[Docket No. 2004-SW-09-AD; Amendment 39-13651; AD 2004-06-51]

Airworthiness Directives; Boeing Defense and Space Group Model 234 Helicopters

2004-06-51 Boeing Defense and Space Group: Amendment 39-13651. Docket No. 2004-SW-09-AD.

Aft Vertical Shaft
Assembly Inspection Area
Figure 1

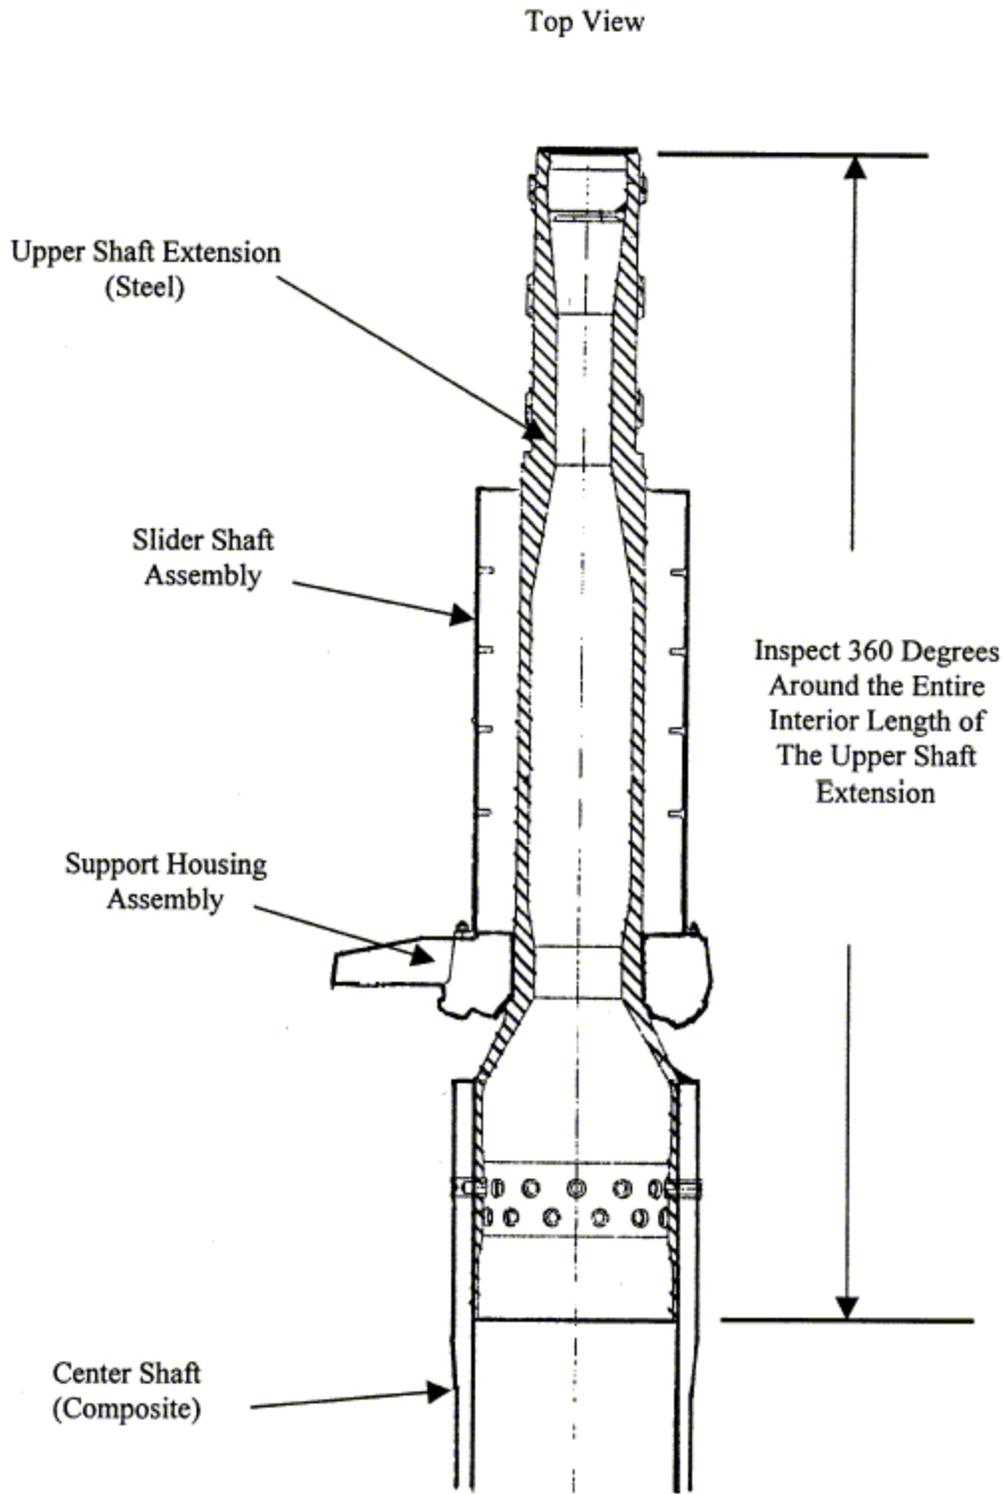
(5) Inspect the upper shaft extension, P/N 114D3248, using a borescope or other lighted device that provides direct visual observation of the interior of the aft rotor shaft. Inspect 360 degrees around the entire interior length of the upper shaft extension. If any crack is found, replace the aft vertical shaft assembly, P/N 234D3300, with an airworthy assembly before further flight. See the following Figure 1 of this AD for the area to inspect:

(3) Inspect the upper shaft extension, P/N 114D3248, using a borescope or other lighted device that provides direct visual observation of the interior of the aft rotor shaft. Inspect 360 degrees around the entire interior length of the upper shaft extension (see Figure 1 of this AD). If any crack is found, replace the aft vertical shaft assembly, P/N 234D3300, with an airworthy assembly before further flight.

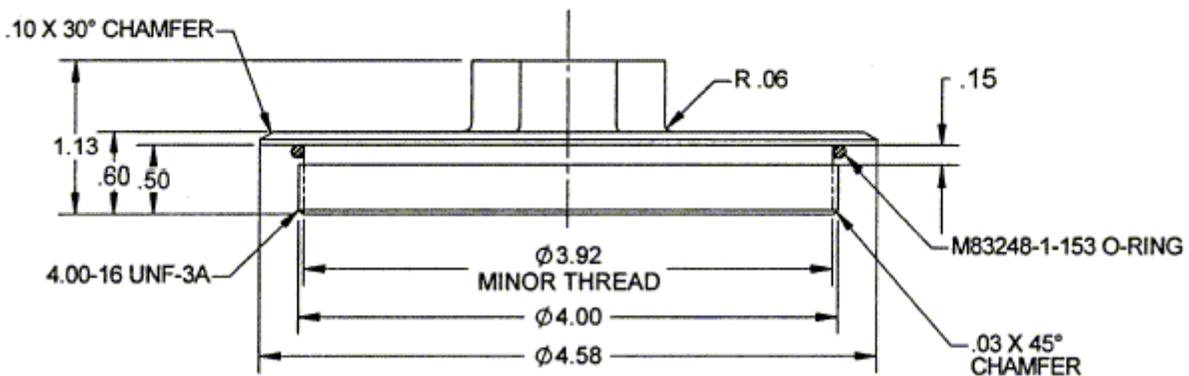
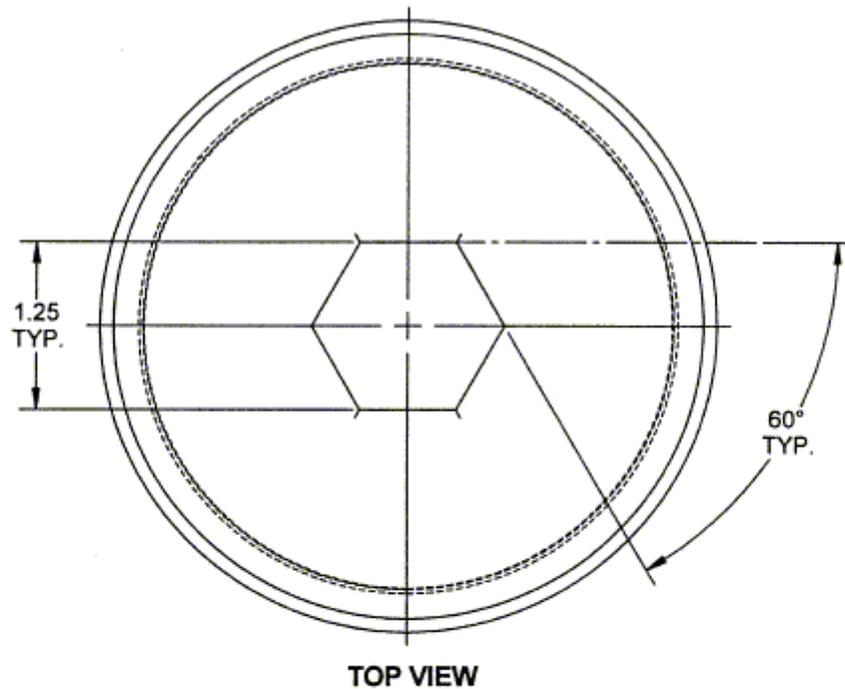
(7) Manufacture an aluminum-threaded plug to replace the rubber plug, P/N 114D1246-1. The replacement plug is to be installed in the internal threads on the top of the upper shaft extension. Machine the plug from a block of 7050-T7451, 7075-T6 or 6061-T6, with 4.000" -16 UNS-3A threads and a minor thread diameter of 3.920". Machine a hex head to the center of the cap to aid in removal. Machine the hex head to fit a 1 1/4" wrench. See the following Figure 2 of this AD:

(8) Install the aluminum-threaded plug with an o-ring, P/N M83248-1-153, in the internal threads on the top of the upper shaft extension (hand tighten only). Assure the safety wire for the rotor hub nut is clear of the plug.
